HEADQUARTERS AERONAUTICAL SYSTEMS DIVISION (AFSC)

SUBJECT: ASD Addendum Report to FTC-TR-71-39 26 Jan 72

UH-1N
CATEGORY II PROPULSION SYSTEM EVALUATION

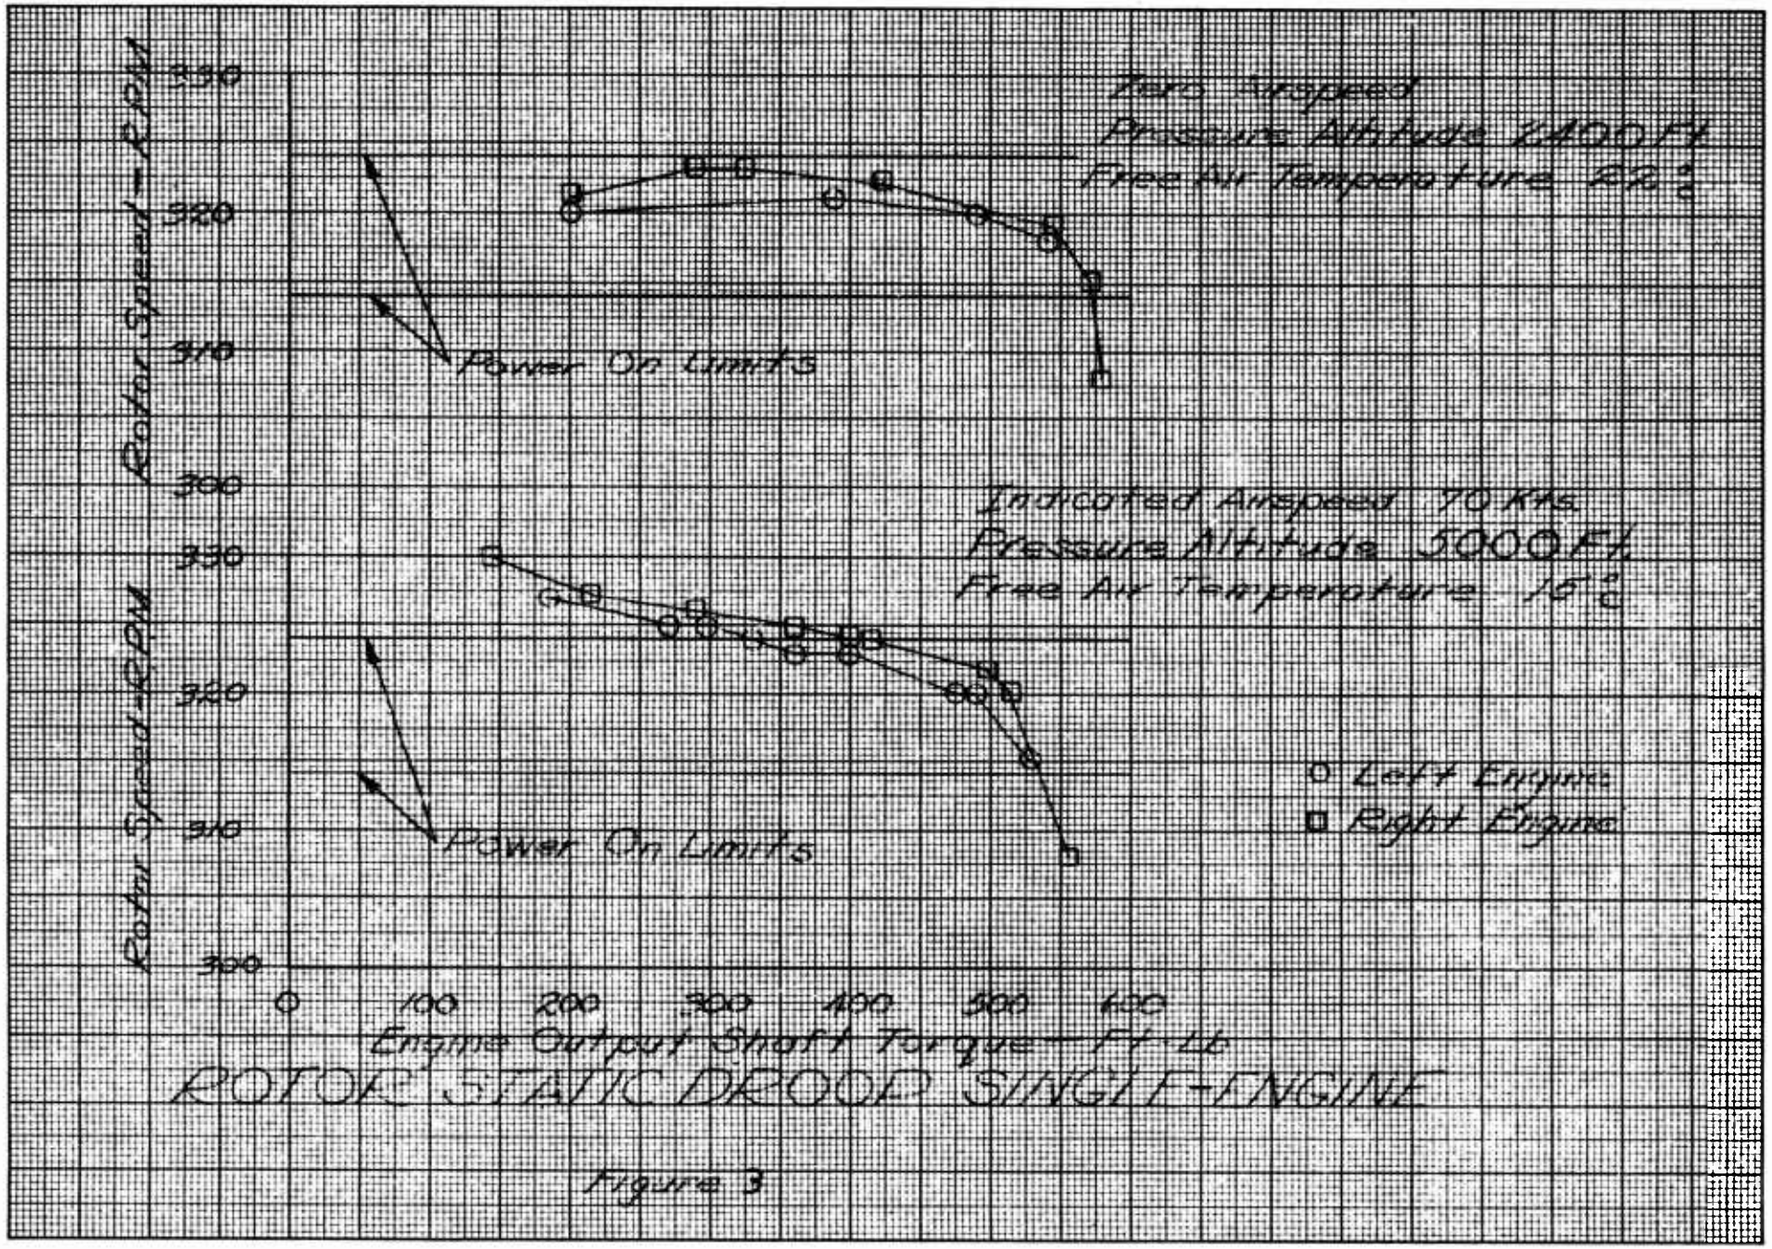
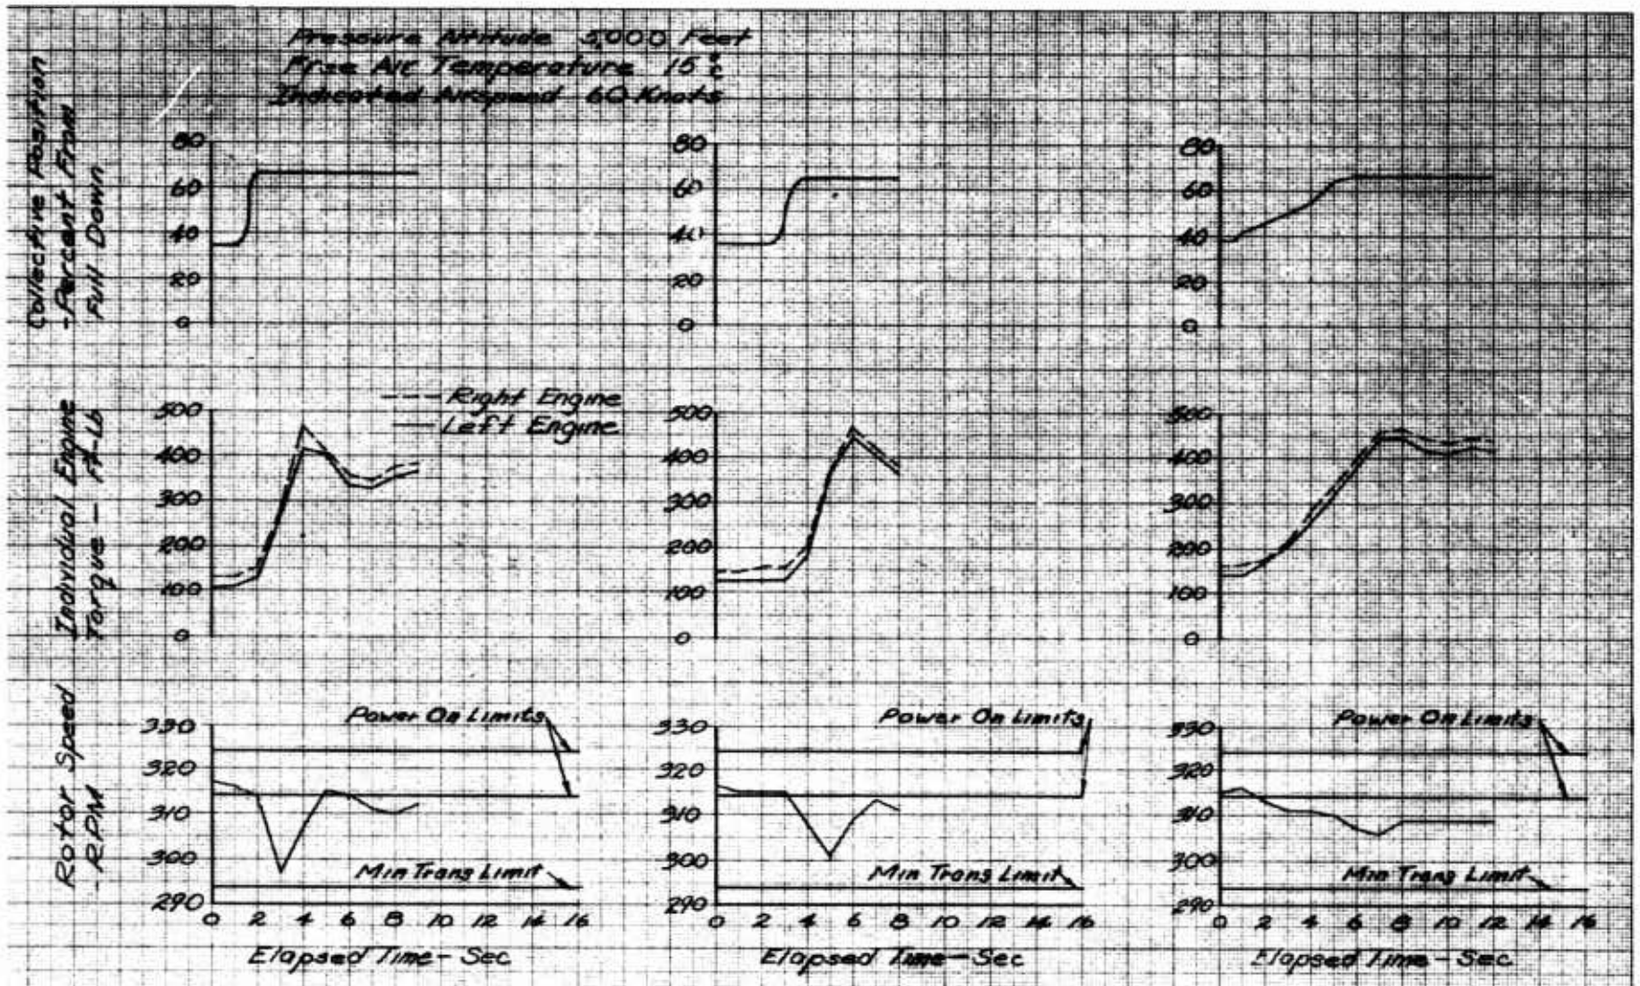
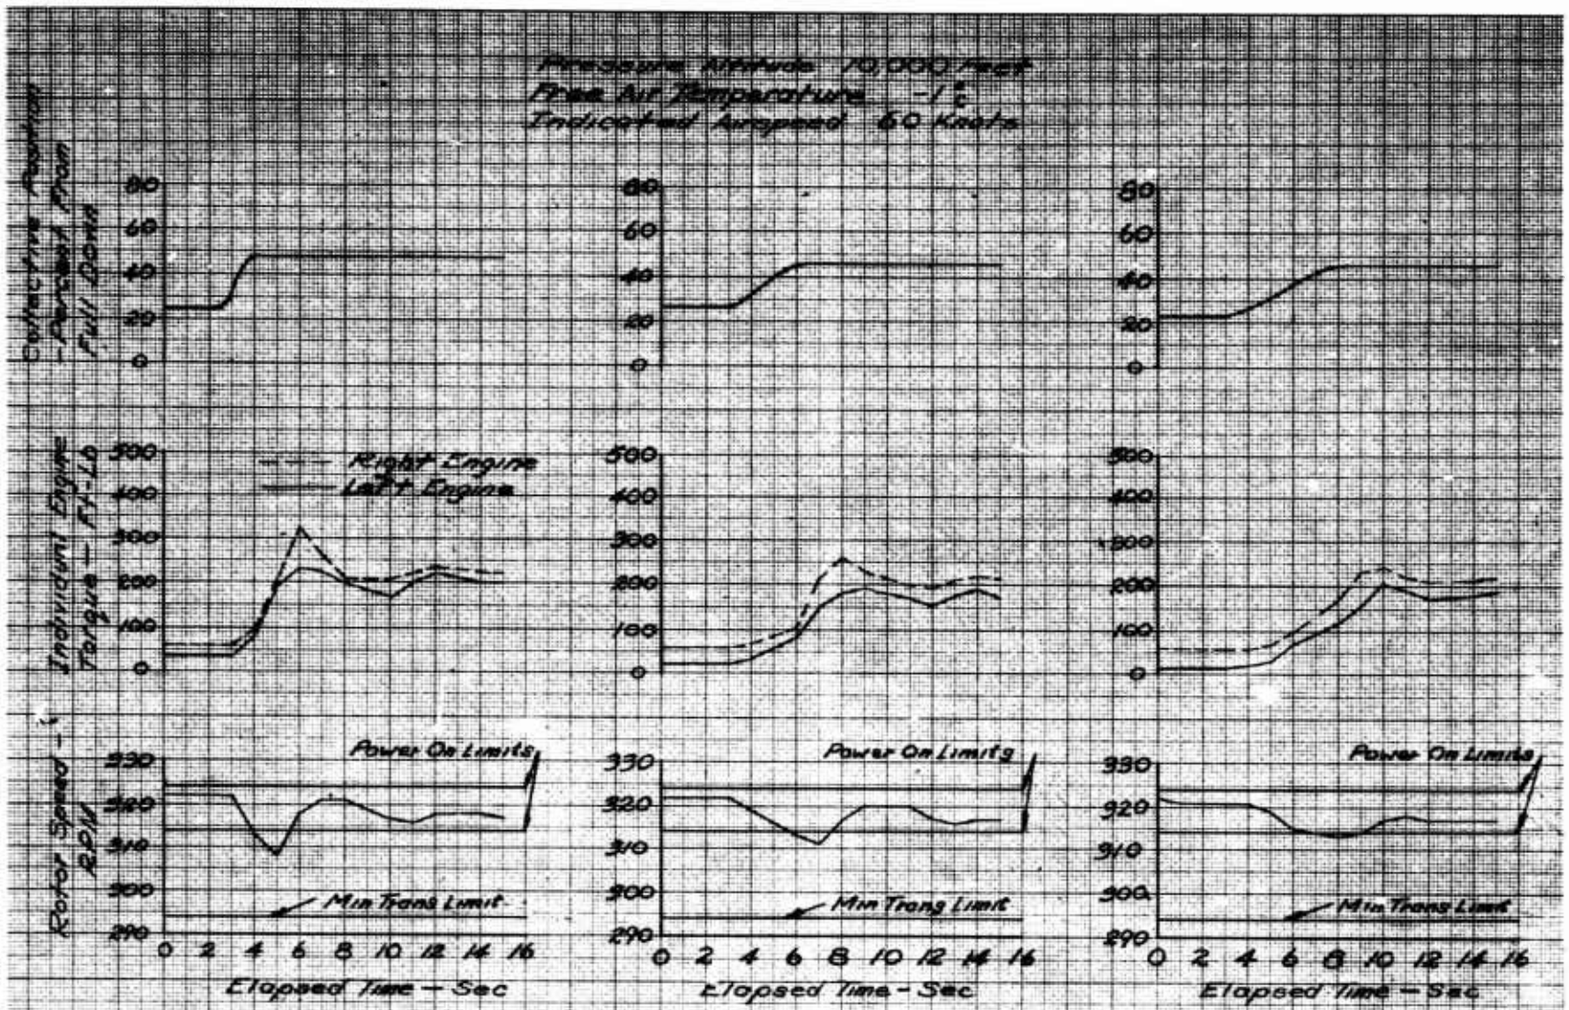
All transients exhibited a characteristic one cycle overshoot in torque and rotor rpm, with the overshoot more pronounced at the highest collective pitch control transients rates. This presented no problem during the testing. However, it was possible that the engines would overtorque if rapid collective pitch control movement to a high setting was attempted. A CAUTION should be added to the Flight Manual stating that this type of collective pitch control movement should be avoided. (R 8)

8. Concur with intent. Abrupt movement of flight controls is prohibited by section V of the flight manual. No further action is planned.

Figure 8

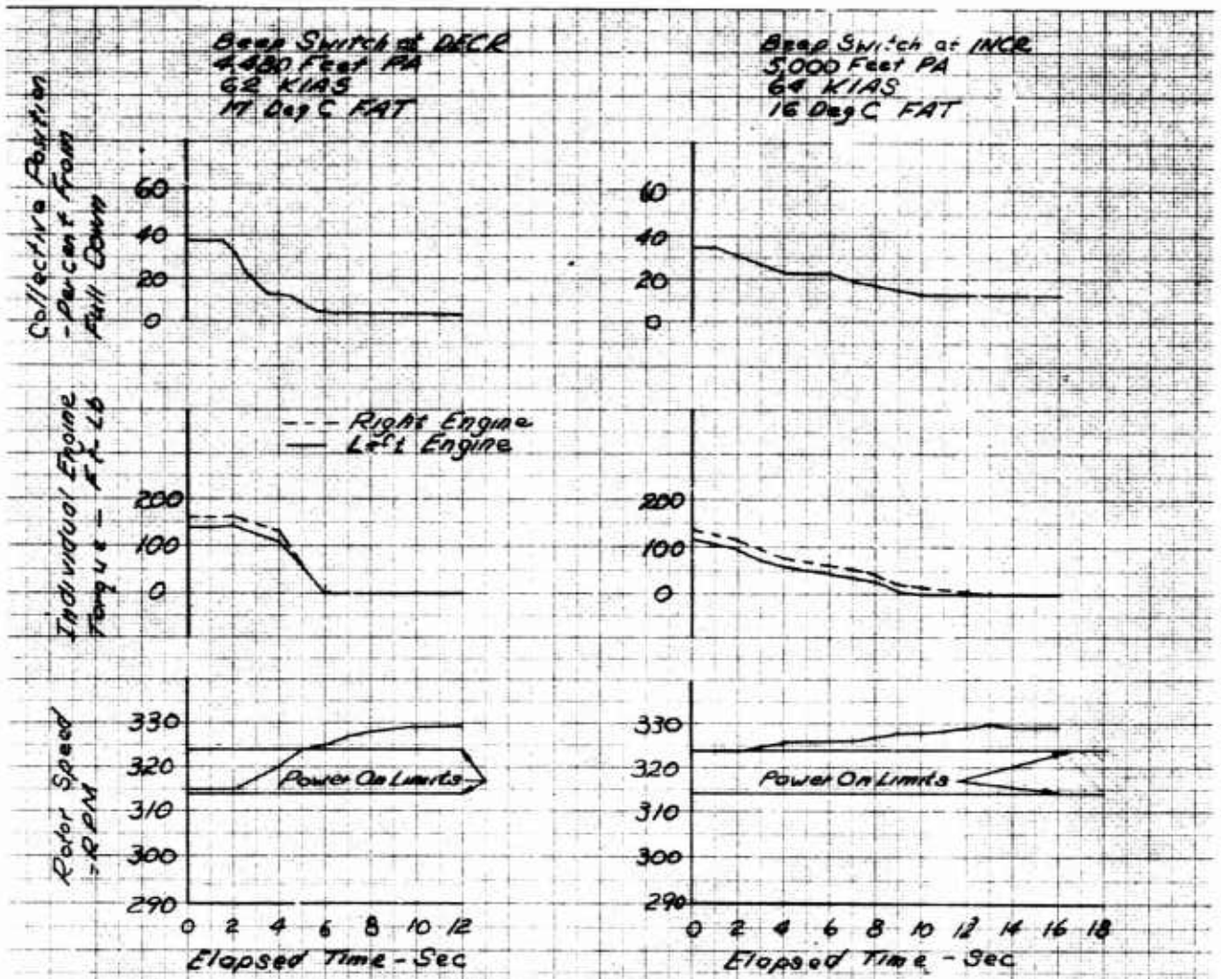
Figure 8 presents time histories of N_R, engine torque, and collective pitch control position for two typical engine transient tests in which the collective pitch control was lowered, first with minimum beep and then with maximum beep. In both cases rotor speed exceeded the power on limit of 324 rpm, even though the rate of collective pitch control movement was slow (5 and 9 seconds, respectively). Although not tested due to safety reasons, rotor speed could be expected to exceed even the maximum transient power-on limit of 338 rpm in the event the collective pitch control was lowered rapidly (one second or less) from a high power setting. These data indicate that rotor compensation characteristics were inadequate to maintain rotor speed within power-on limits even when minimum beep was applied. Rotor speed compensation should be improved to prevent rotor overspeed during engine transients induced by lowering of the collective pitch control. (R 9)

9. Do not concur. Costs associated with the recommended change are not commensurate with the anticipated benefits. Flight manual coverage of this characteristic should suffice. ASD has initiated action to incorporate the required information in the flight manual.

Figure 17

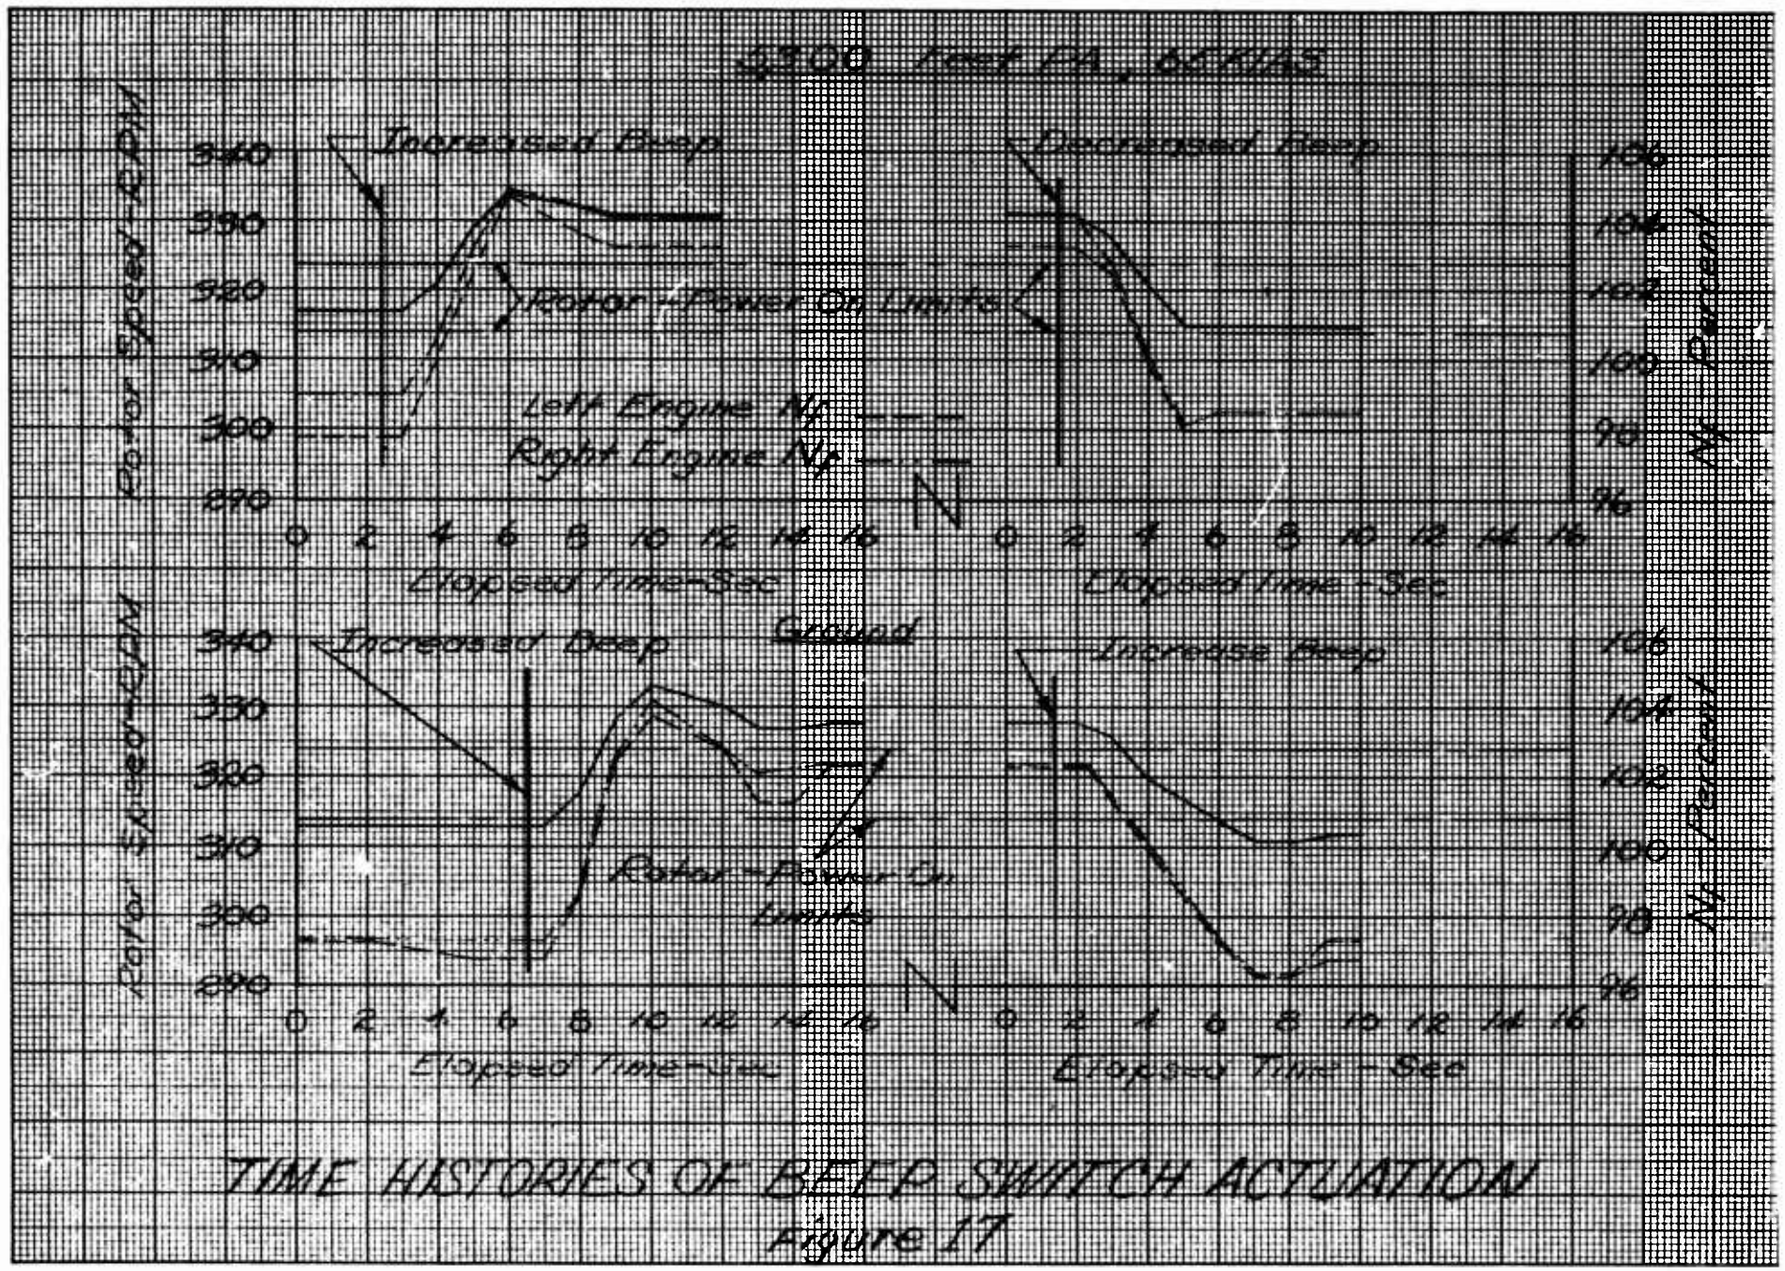
Time histories of N_R and N_f during increasing and decreasing beeps are shown in figure 17. Results of both the ground test and flight test were similar. The beep switch permitted an N_f change from 96.8- to 102.5-

percent rpm on the ground, and from 97.8- to 103.3-percent rpm at 5,300 feet PA, 65 KIAS. This beep authority was acceptable. However, a dead band existed when changing from INCR to DECR or DECR to INCR. This dead band resulted in a rotor speed change delay of from one to one and one half seconds. In addition, N_f overshoot occurred when INCR was actuated with the rotor speed at minimum. This overshoot in N_f resulted in rotor overspeed as much as 9 rpm above the normal power-on limit of 324 rpm. The N_f governor response to beep switch actuation in INCR should be redesigned to eliminate the overshoot in rotor speed. (R 10)

10. Do not concur. Frequency of this occurence is rare. The cited overspeed amounted to less than 1/3 of 1%. Costs associated with this change are not commensurate with the benefit to be derived.
